## Groundwater Application Review Summary Form

Application # G- 18382-RR

TO: Water Rights Section Date October 23, 2017  
 FROM: Groundwater Section Michael J Thoma  
 Reviewer's Name  
 SUBJECT: Application G- 18382 Supersedes review of December 12, 2016  
 Date of Review(s)

**A. GENERAL INFORMATION:** Applicant's Name: Rogue's Lair Farms LLC County: Jackson

### Well Log Statistics from Sections Surrounding the Proposed POAs

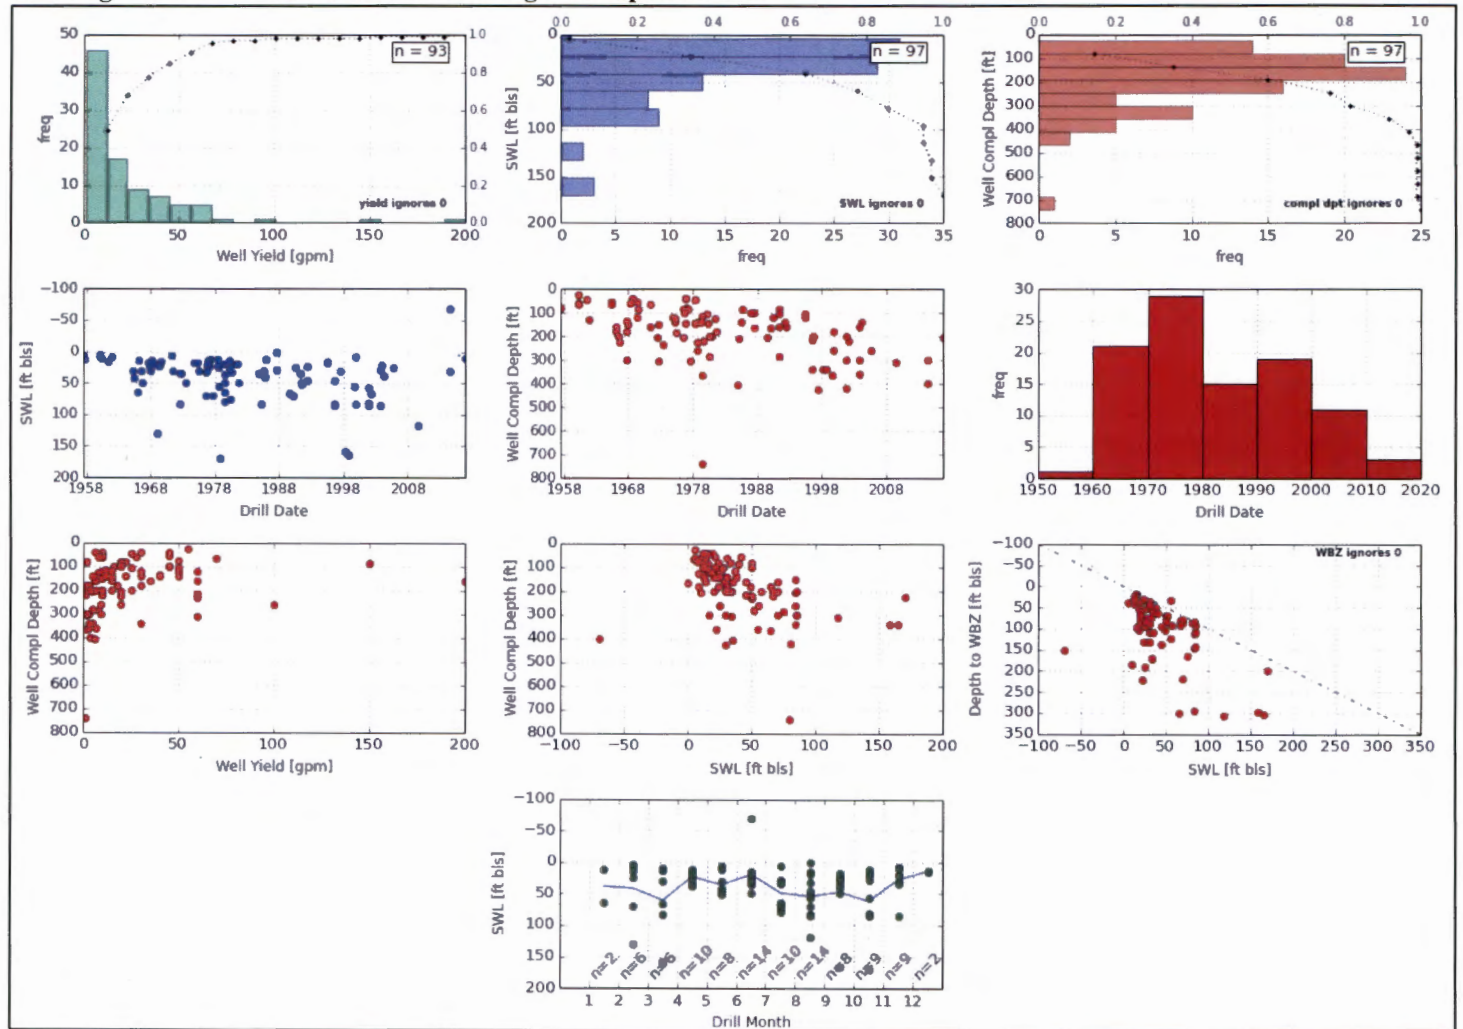
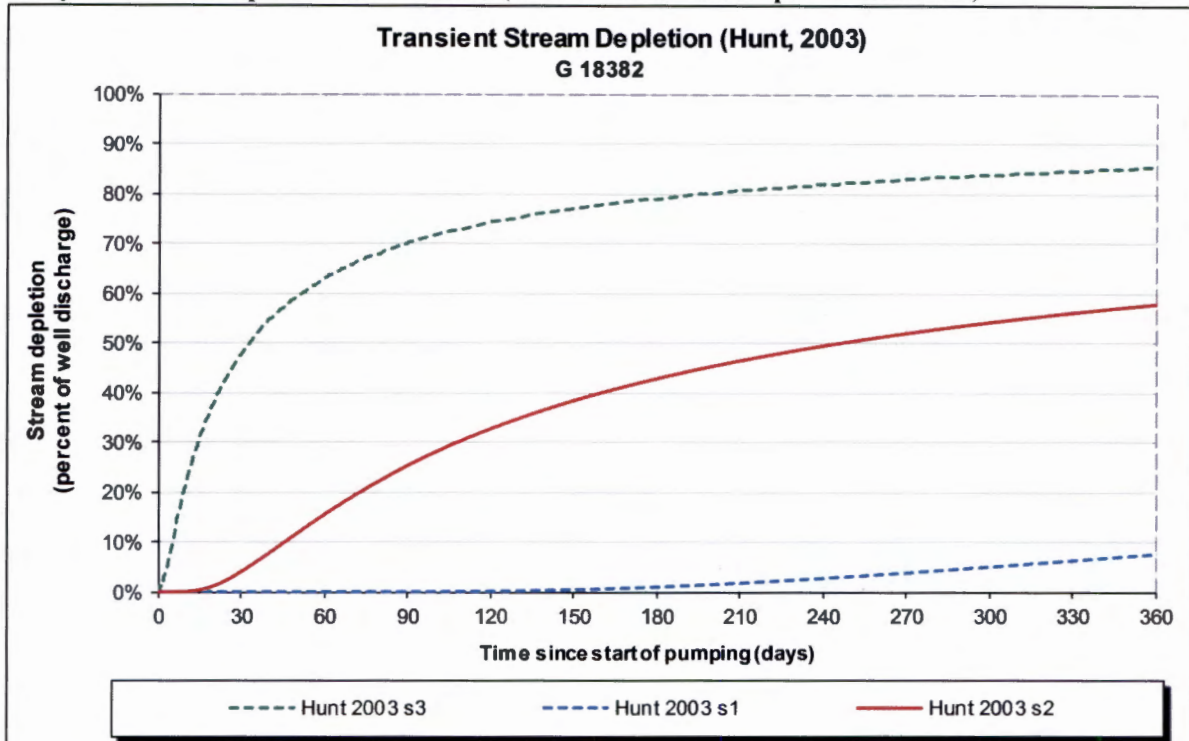
The applicant originally proposed a rate of 1.97 cfs which was deemed to be beyond the capacity of the resources based on median well yields in the area. The applicant’s adjusted rate of 0.22 cfs (100 gpm) is still in much higher than median well yields but several well logs in the area report yields > 50 gpm. Also, given that this rate will be divided between two wells, and that this describes the maximum appropriation rate – actual pumping rate will be much less and likely limited by well yield – the adjusted rate is deemed appropriate.
